Re: Harold D. Thompson Regional Water Reclamation Facility (HDTRWRF)
Lower Fountain Metropolitan Sewage Disposal District (LFMSDD)

Submittal No.:	11160-001B
Date of Submittal:	October 31, 2012
Supplemental Information:	November 20, 2012
Title:	Aeration Basin Mixers and Hoist
Specification Section:	11160
Manufacturers:	Grundfos; International Protective Coatings; Halliday Products, Inc.

The referenced submittal has been stamped "***No Exception Taken***" and "***Revise and Resubmit***".
Our comments are as follows:

1 TYPICAL MIXER DETAIL
 AB-13 SCALE: NONE

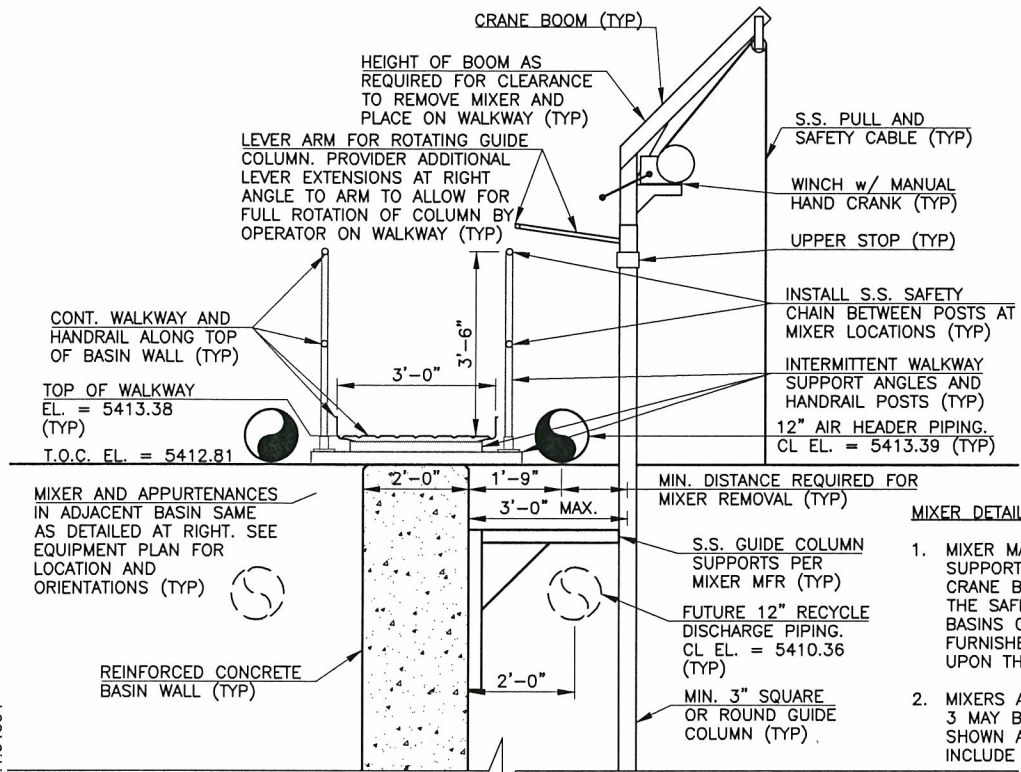
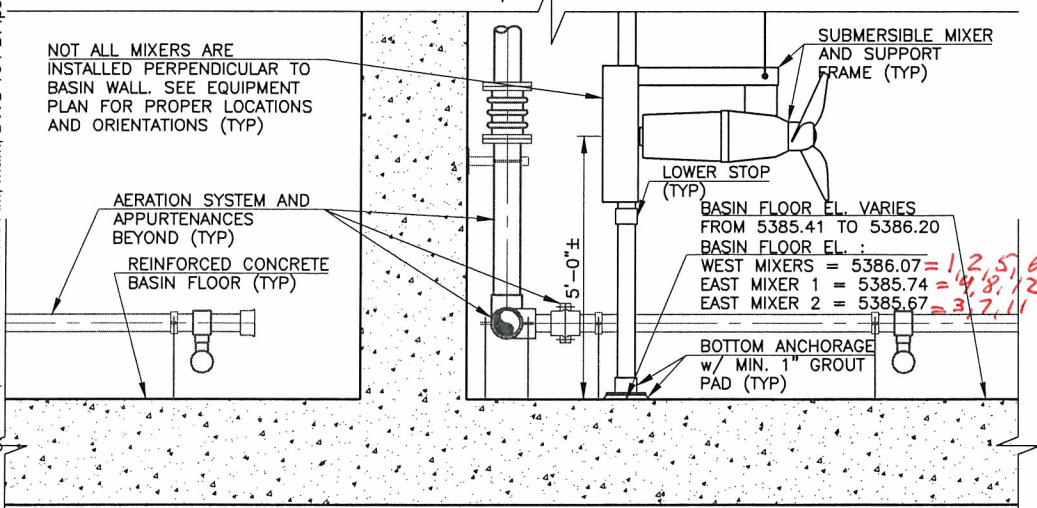
After a second resubmittal, I finally understand your comments concerning mixer locations. Thank you for taking the step of sending me the location numbers on the "Typical Mixer Detail".

As discussed during our phone conversation, this drawing was the only document I was working from other than the plan view of the installation. From the mixer detail we had assumed there were ten (10) mixers labeled as "West Mixers" and one (1) at each of the "East Mixers" locations.

3. Comment No. 7: Attached is my tally of mixer mast lengths and required mast bracket extensions handwritten on AB-11, as well as my mixer tag number listing on Detail 1/AB-13. It seems to me that my responses to the mixer mast inquiry form that I sent to you on 9-5-12 still have not been accounted for in this 11160-001B submittal. The 11160-001B submittal responses are still not addressing the mixers according to tag numbers as was requested, which were shown on the AB-11 drawing that was included in my email response to you on 9-5-12.

I've reconciled the mixer mast drawings per your comments and will now show & supply six (6) mixers for West locations 1, 2, 5, 6, 9, & 10, three (3) for East Mixers locations 4, 8, & 12; and three (3) for East Mixer locations 3, 7, & 11. These locations are listed on the attached mixer mast submittal details.
